## MEMORANDUM

**DATE:** August 15, 2016 **PROJECT NO.** 350.0065.001

**SUBJECT:** Addendum No. 2 to the Remedial Investigation Work Plan, Additional Soil Sampling for PCBs at the High Density Pulp Tank Foundation and Transformer Storage Building Foundation Areas, Smurfit Stone/Frenchtown Mill, Missoula County, Montana

**Proposed Soil Sample Locations  
High Density Pulp Tank Foundation  
Former Frenchtown Mill  
Missoula County, Montana  
FIGURE 3**

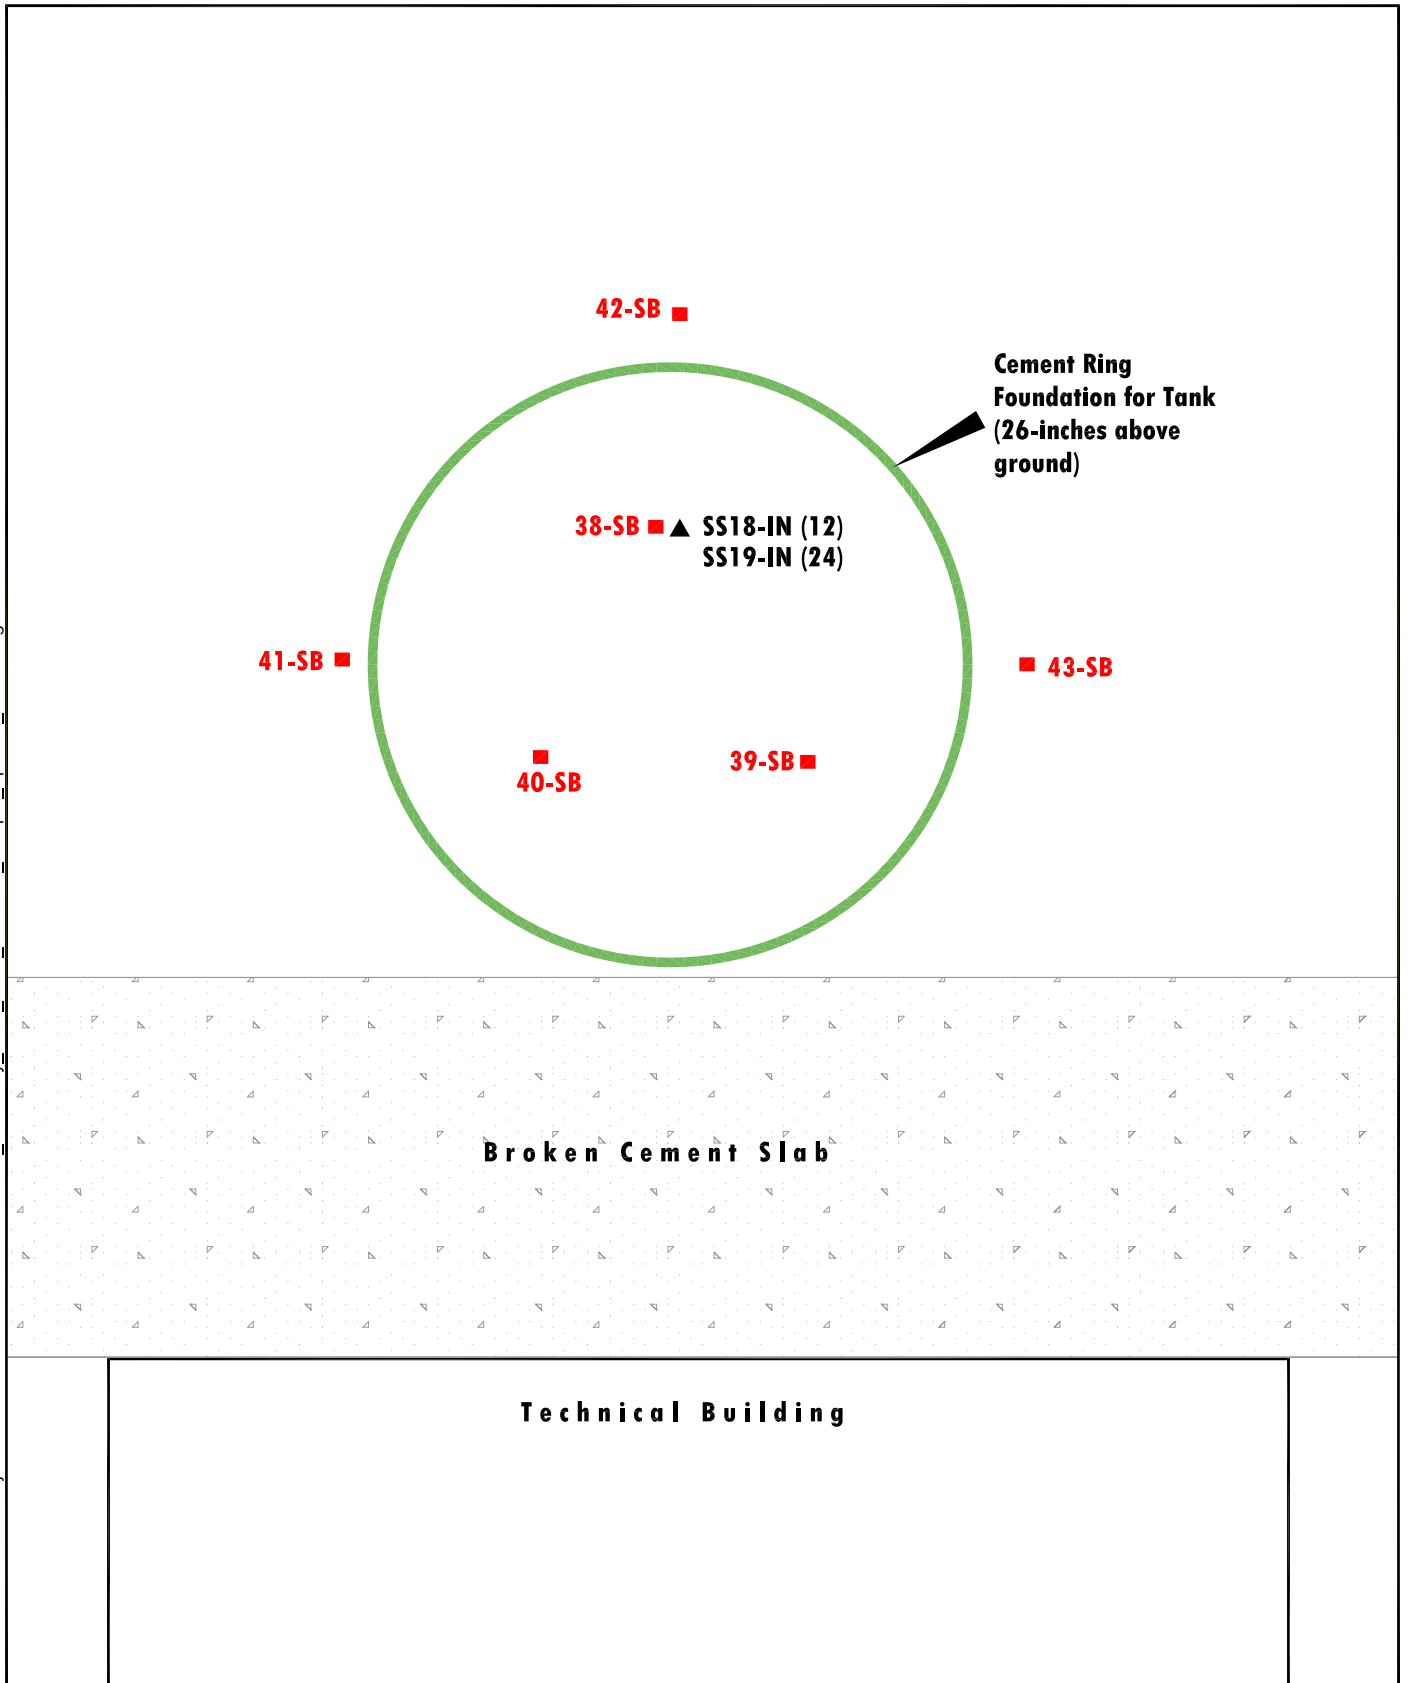
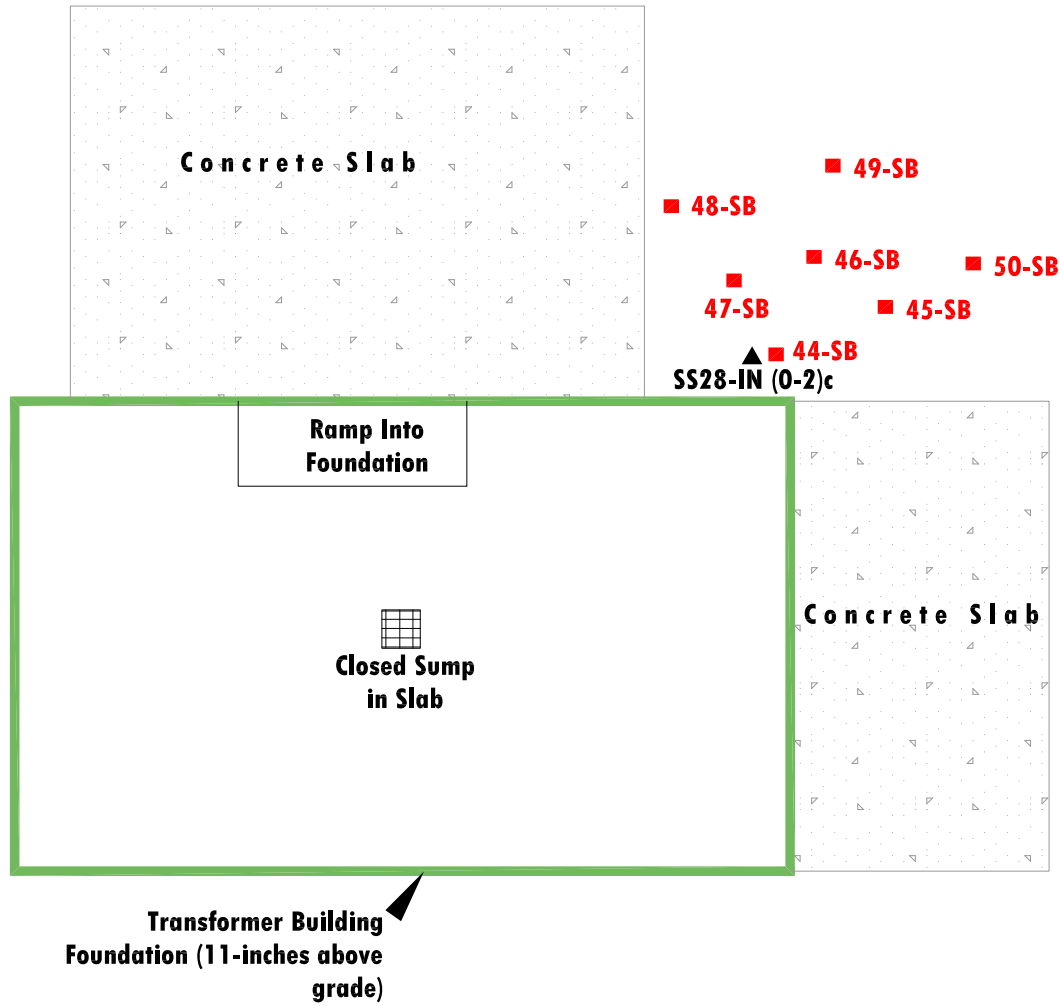
**Figure 3** shows proposed locations for six soil samples; three within the HDPT ring foundation and three outside the foundation. Direct-push drilling techniques (e.g., Geoprobe®) will be used to obtain samples to depths of 4 feet in accordance with SOP-14 (NewFields 2015b), included in the RIWP. **Table 1 (Attachment B)** identifies sampling depths.

Decontaminated direct-push sampling rods lined with acetate sleeves will be advanced to 4 feet at each sampling location shown on **Figure 3**. Sample locations residing outside the tank foundation were determined during a site visit with NewFields, EPA, and MDEQ on August 2, 2016. Locations were selected to avoid areas with concrete surfaces. After the rods are retrieved and the sample sleeves removed, the recovered sample will be placed on a work table. The soil stratigraphy and percent
